PARTE I: DECLARACIÓN

DePue/New Jersey Zinc/Mobil Chemical Corp.
0110300003 – Condado de Bureau
No. de ID de CERCLIS ILD 062 340 641
Unidad operable 4, suelos fuera del sitio
DePue, Condado de Bureau, Illinois

Este Registro de Decisión (ROD, por sus siglas en inglés) presenta la reparación seleccionada para el sitio de DePue/New Jersey Zinc/Mobil Chemical incluido en la Lista Nacional de Prioridades (NPL, por sus siglas en inglés), la Unidad operable (OU) 4, en DePue, Illinois, que fue escogido por la Agencia de Protección Ambiental de Illinois (EPA de Illinois) de acuerdo con la Ley Integral de Respuesta Ambiental, Compensación y Responsabilidad de 1980 y sus enmiendas (CERCLA, por sus siglas en inglés), y sus enmiendas por la Ley de Enmiendas y Reautorización del Superfondo (SARA, por sus siglas en inglés) y, en la medida en que resulte factible, el Plan Nacional de Contingencia para la Contaminación por Petróleo y otras Sustancias Peligrosas (NCP, 40 Código de Regulaciones Federales (CFR) 300-399). Esta decisión está basada en el expediente del Registro administrativo para este sitio.

Figure 2.
Operable Units (OU's) within NPL Site

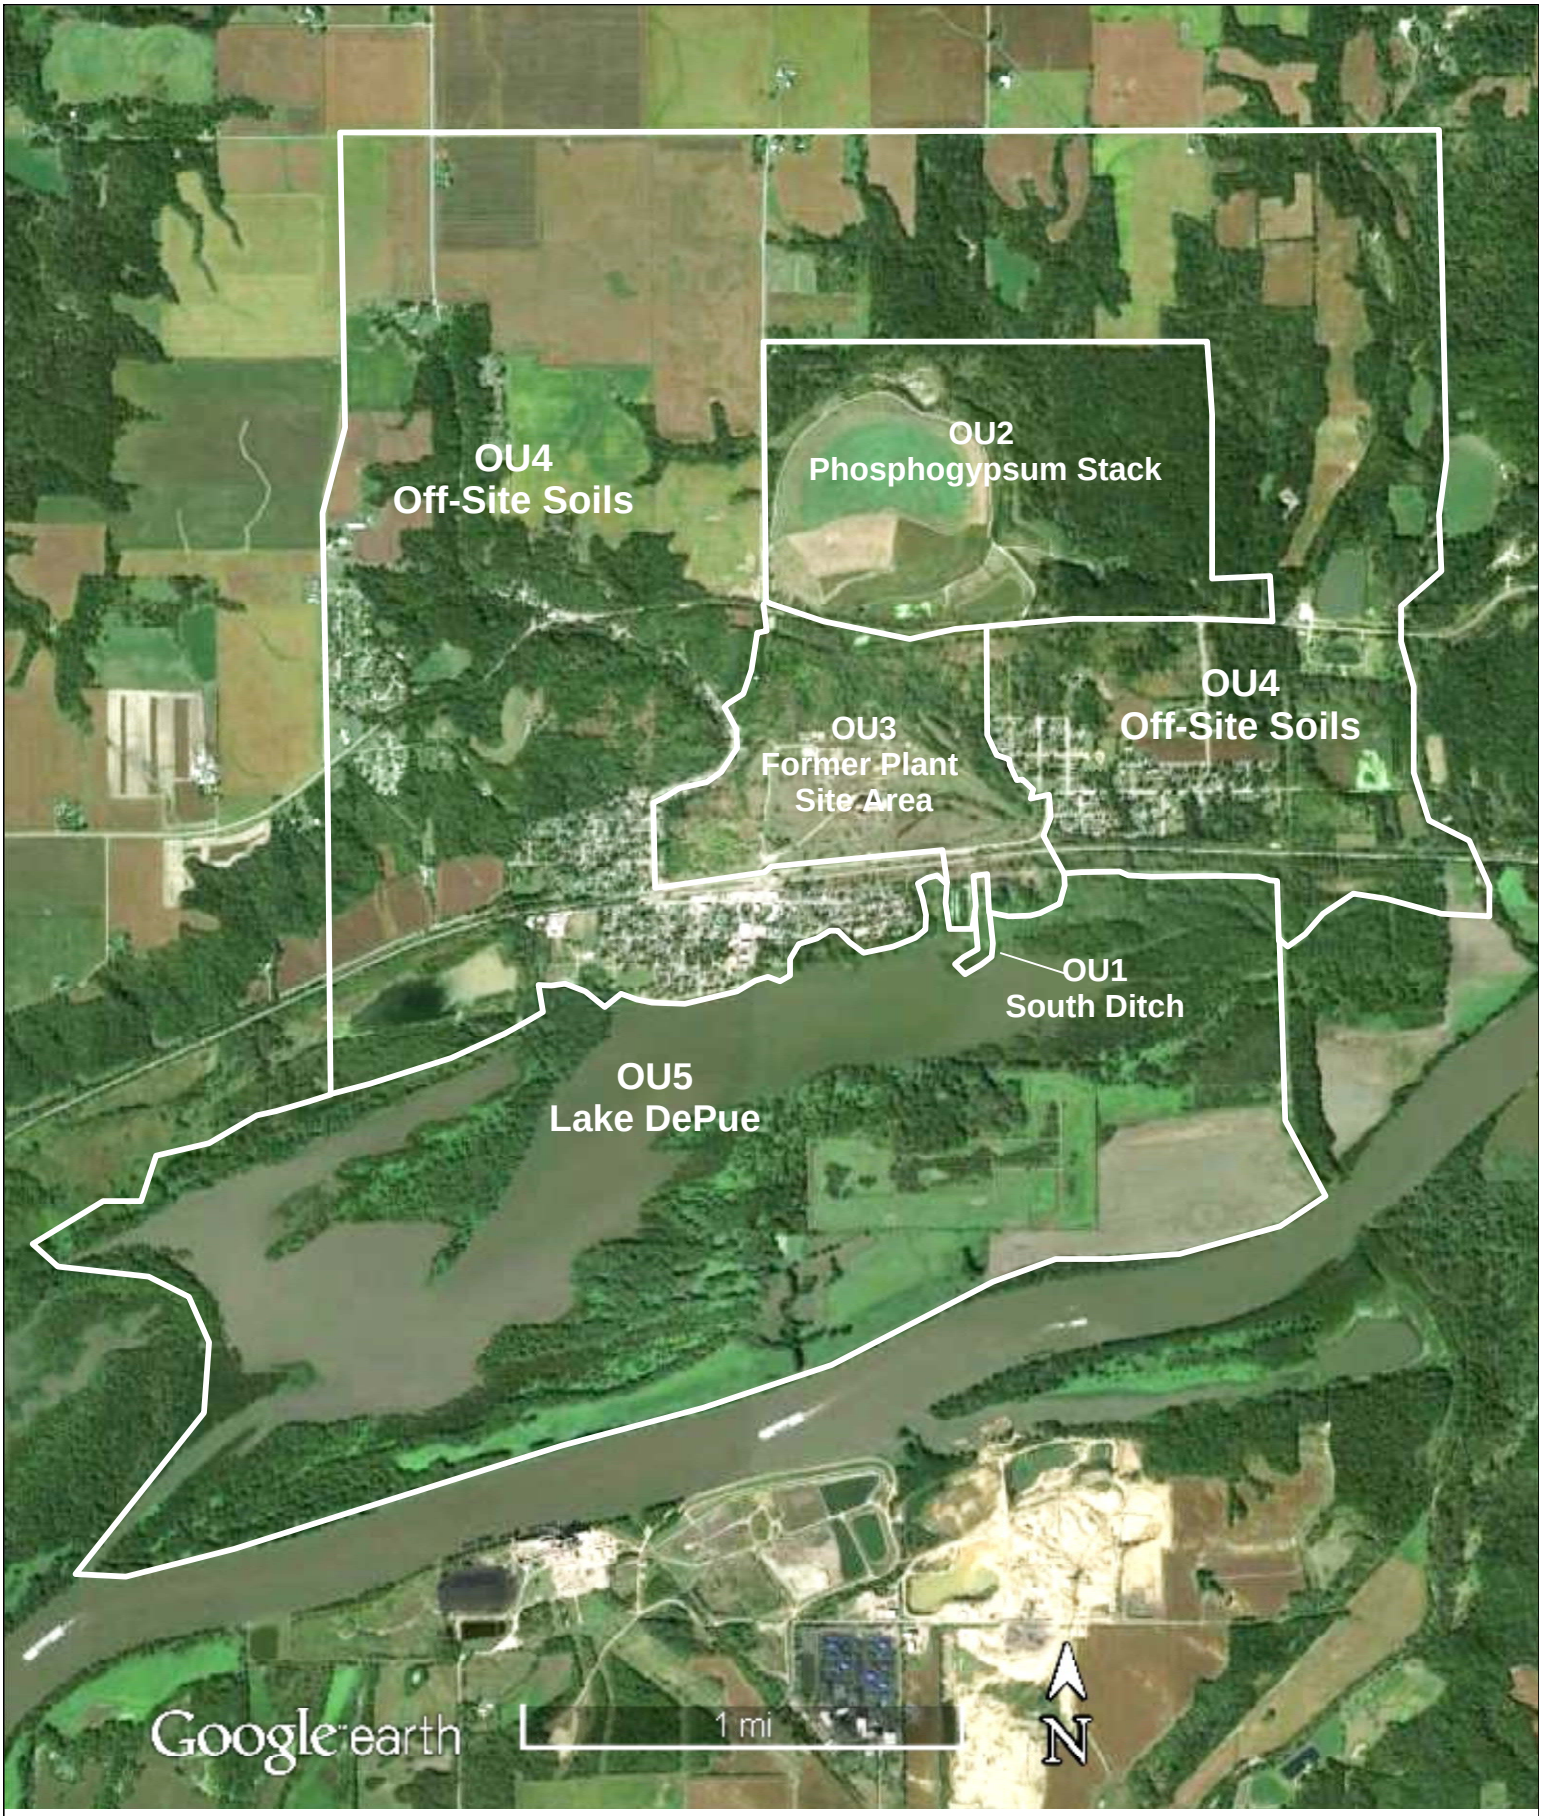
CBS Comment #8 The Proposed Plan indicates that "residential properties and parks will be restored using soil from an off-site source…". Because the footprint of the site as shown on Figure 2 of the Proposed Plan is large and some soils within this area may meet the criteria for backfill soil, the ROD should clarify that backfill soil may be obtained from areas within the defined site boundaries (i.e., within OU2, OU3, and OU4) provided the results of soil testing confirm that the backfill soil meets residential PRGs for the HCOPCs and TACO Tier 1 Soil remediation objectives for non-HCOPC chemicals.

Illinois EPA Response:
